**ZONING AMENDMENT  
& SUBDIVISION STAFF REPORT****Date: June 18, 2015****APPLICANT NAME**

Aaiden Place Subdivision

**LOCATION**2480 Government Boulevard  
(North side of Government Boulevard, 520'± West of  
Pinehill Drive)**CITY COUNCIL  
DISTRICT**

B-2, Neighborhood Business District

# DETAIL SITE PLAN

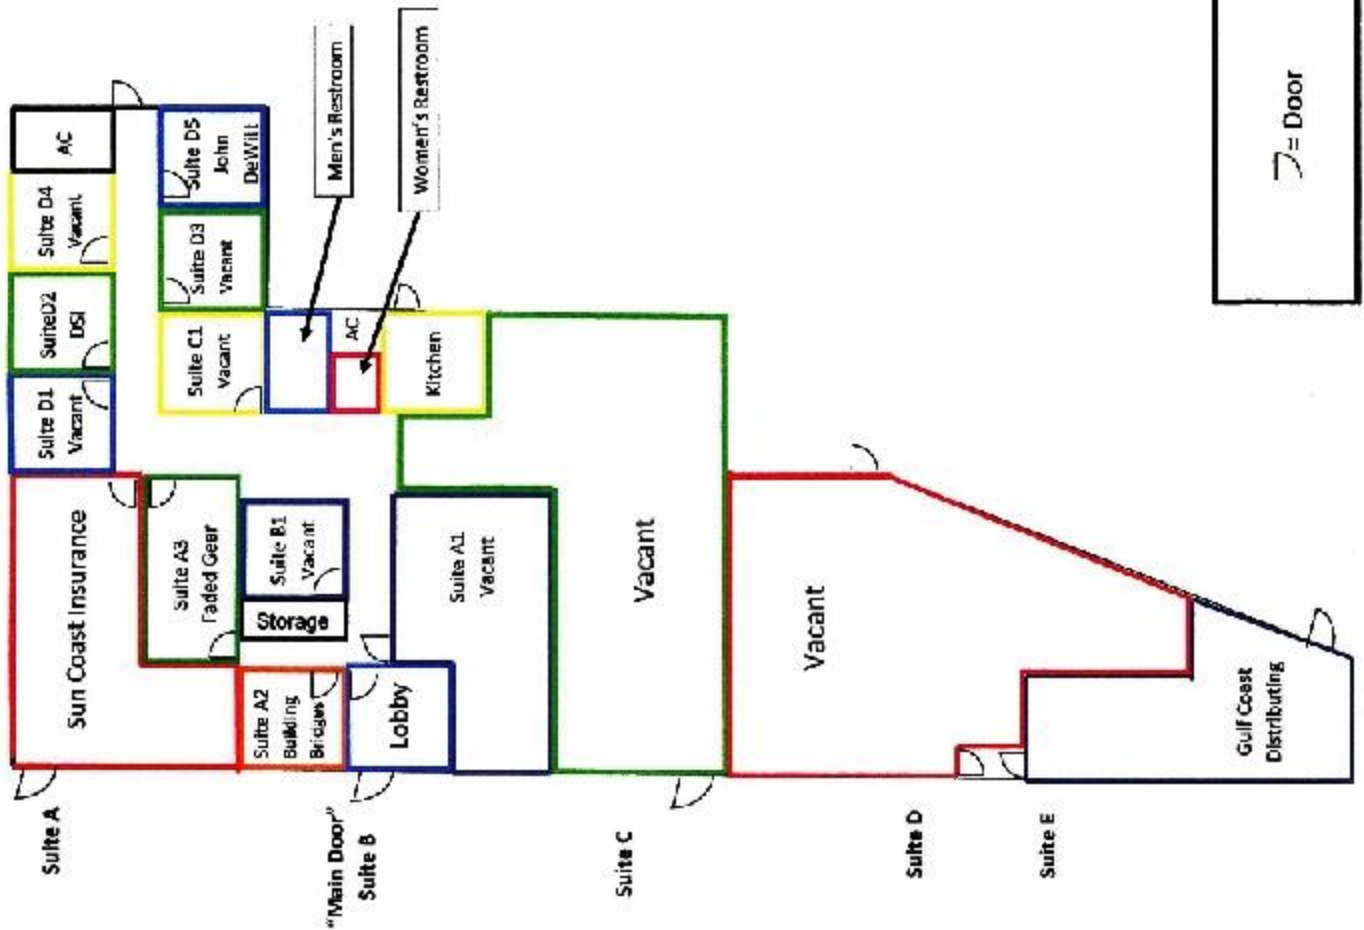
It should be noted that the site plan submitted does not accurately reflect the existing conditions on the site and is missing information. The site plan appears to be to-scale, but the scale is not provided. If approved, the site plan should be revised to state the appropriate scale.

The site plan illustrates 22 parking spaces, but the parking spaces are either not to scale or are not the required minimum size of 9' wide by 18' long. While the applicant does not provide the building size, it appears to be approximately 8,158 square feet, which would require a total of 27 parking spaces for office and retail uses. It also appears based on the site plan provided and aerial photos of the site that the parking spaces may be partly in the right-of-way, with all maneuvering areas located in the right-of-way. There appears to be a large paved area on the Western portion of the site that is not illustrated on the site plan, but could provide parking and maneuvering areas for the site on private property.

No mention is made on if the site will utilize a dumpster or curb-side pickup. The site plan should be revised to either include a note stating that curb-side pickup will be utilized or illustrate a dumpster enclosure with sanitary sewer connection compliant with Section 64-4.D.9. of the Zoning Ordinance.

Because the site is adjacent to R-1, Single Family Residential to the North, a residential buffer compliant with Section 64-4.D.1 of the Zoning Ordinance should be provided. The site plan does not make any mention of if a residential buffer exists, or is proposed to be erected. If approved, the site plan should be revised to meet this requirement. It should be noted that Section 64-4.D.1. of the Zoning Ordinance requires a 10' protection buffer between residentially zoned properties, and the existing structure appears to touch the property line adjacent to residentially zoned properties to the North.

The site plan provided does not mention the amount of total and frontage landscape area provided. The applicant did illustrate the locations of four existing trees on the site larger than 24" in diameter, but there is no mention of the tree species, or their exact size.

*While the site plan submitted is an improvement from the previously submitted site plan, items such as landscape area and tree plantings are not addressed, the size of the building is not provided, and parking areas are illustrated without parking spaces indicated. Because the site was developed prior to 1987, when landscape area and tree planting requirements came into effect, this site will not be required to comply with these requirements until such a time that the building footprint is either increased or decreased by 50%. Without the size of the building or number of parking spaces provided, it is difficult for staff to determine if the site is compliant, however all parking and maneuvering areas are within the right-of-way. The previously mentioned paved area on the West of the property only has 14' of access to the rest of the site, making it a sub-standard access for two-way traffic.*
